Addendum #1

Date	Owner Property Number	BHDA Project Number
Tue, 23 Apr 2024	501-3450	2326

Project Designation	Project Address
Tooele UT Deseret Peak Sr Seminary	Approx. 2234 North Berra Boulevard Tooele, Utah

ES101

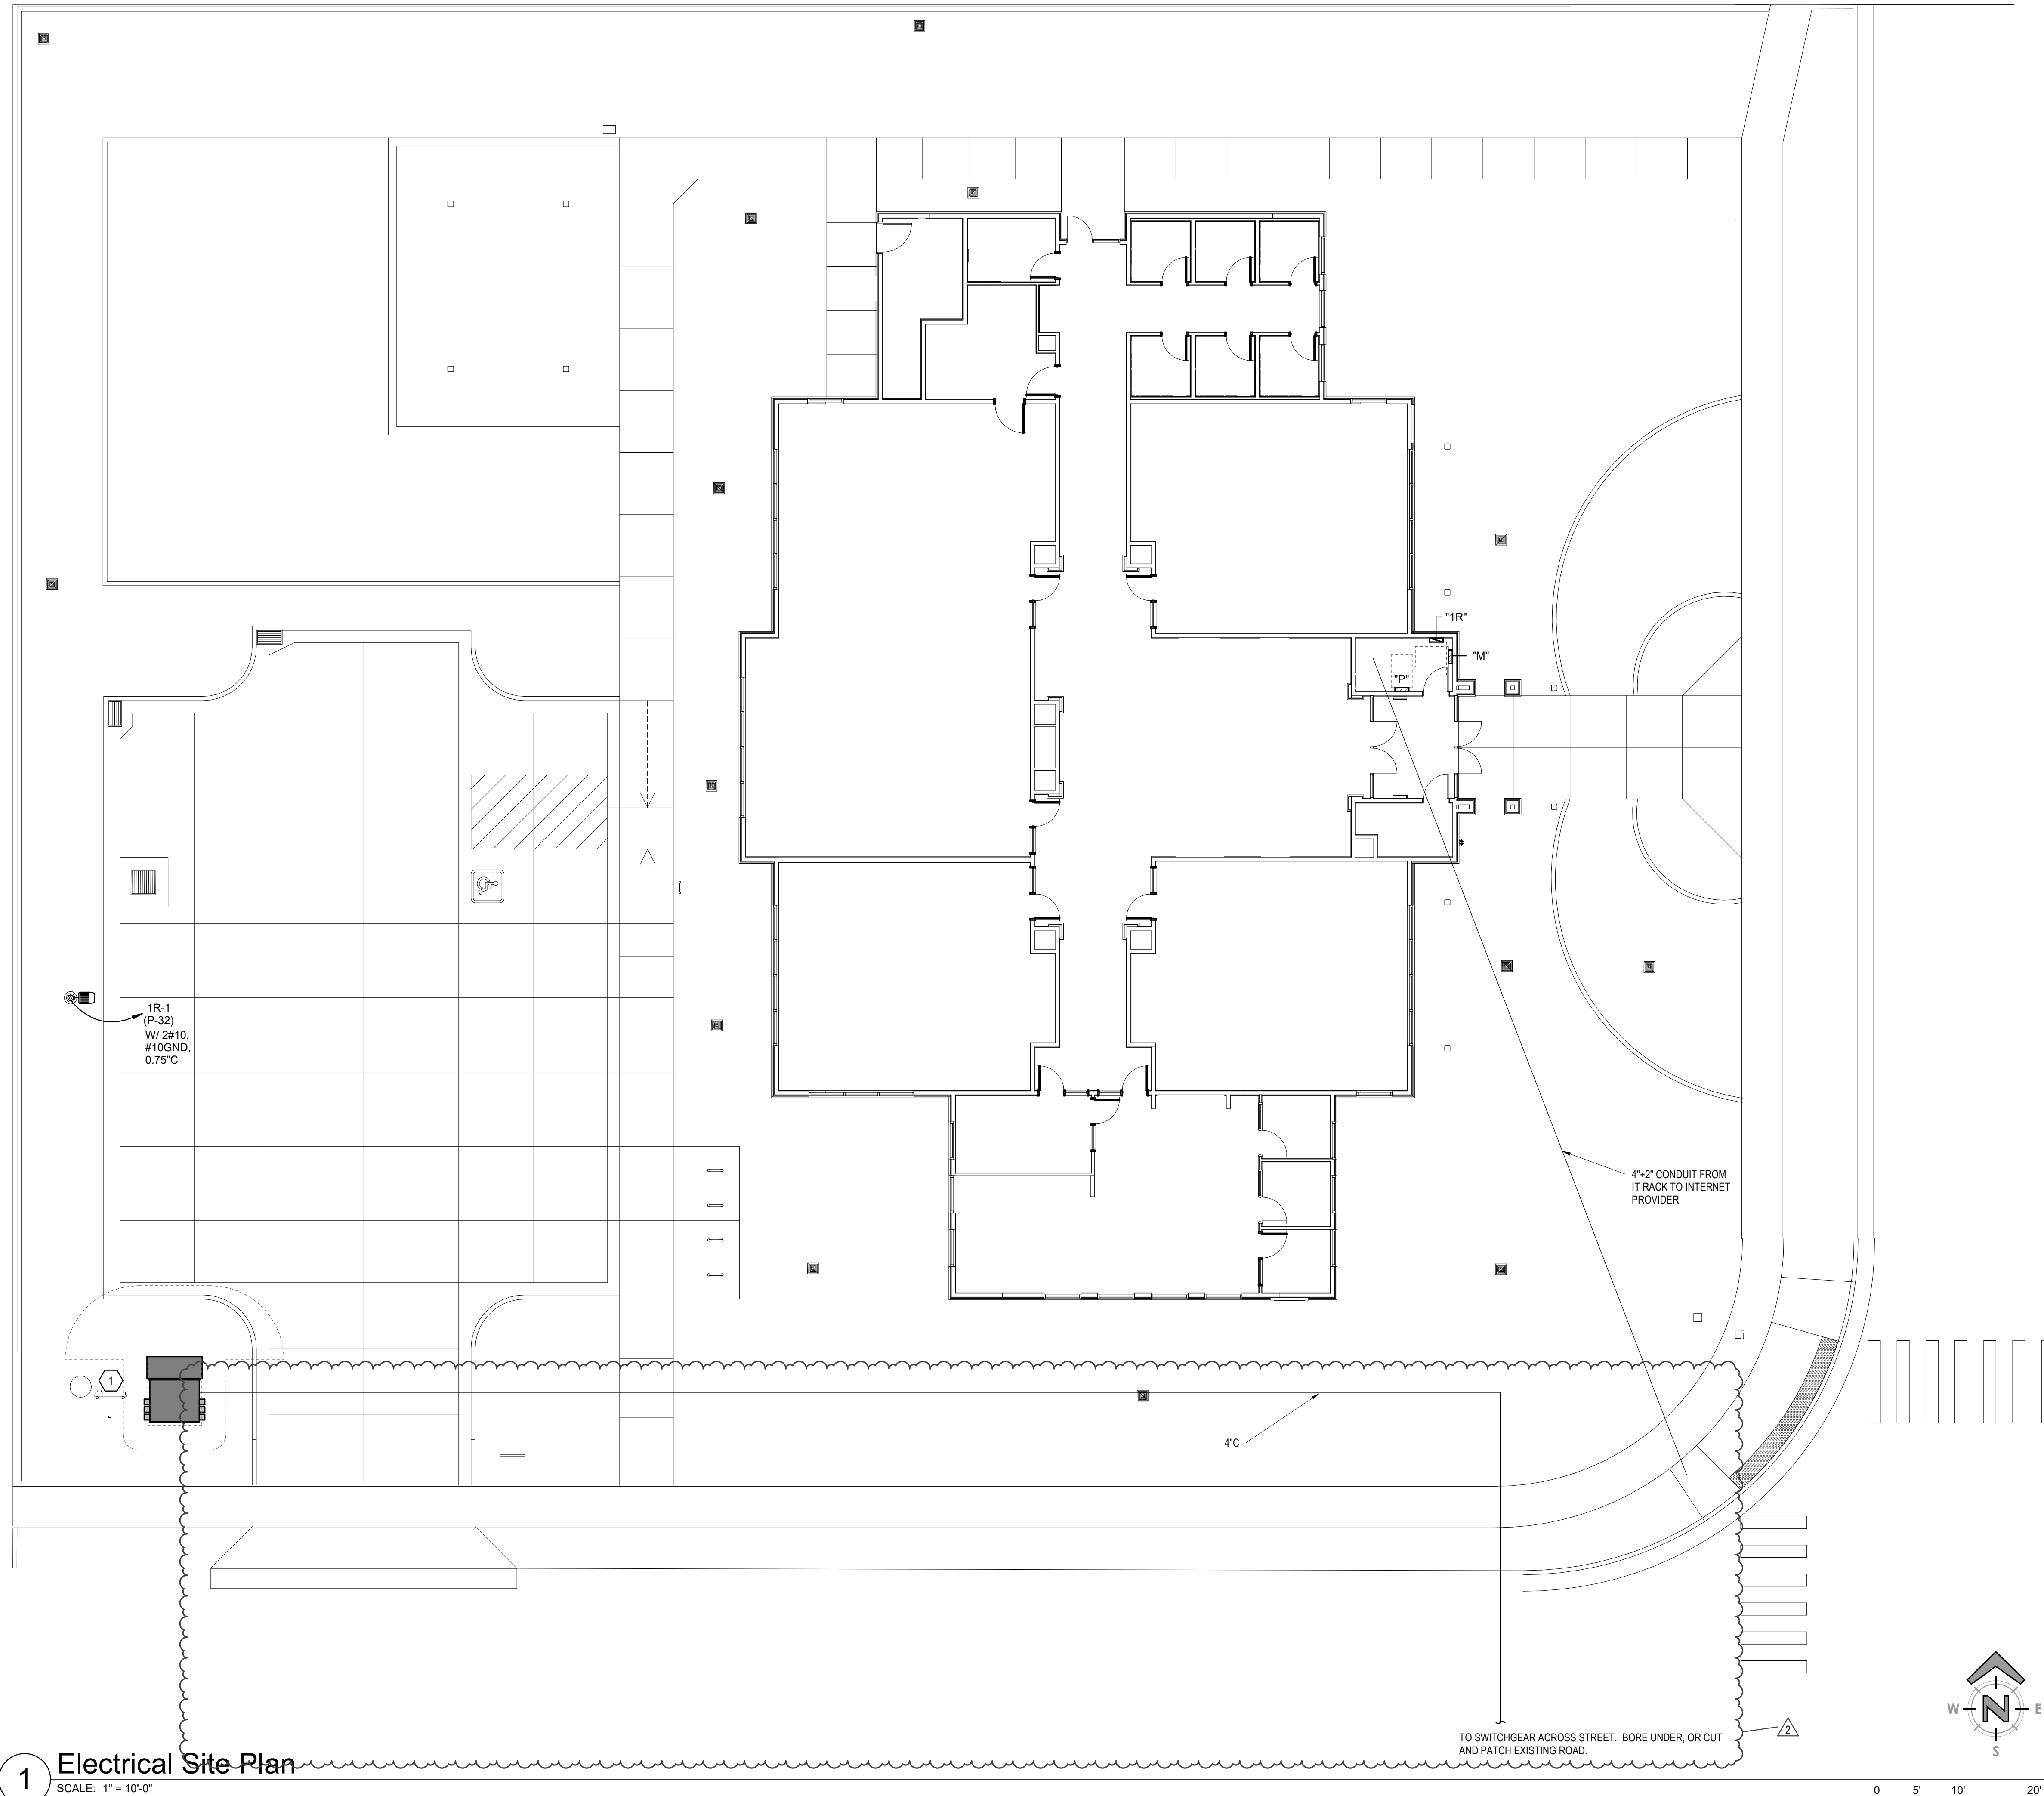
4.06. Sheet ES101 Electrical Site Plan

- A. Replace this sheet with the attached revised sheet.
 - 1. Added a conduit from the site transformer to a switchgear across the street.
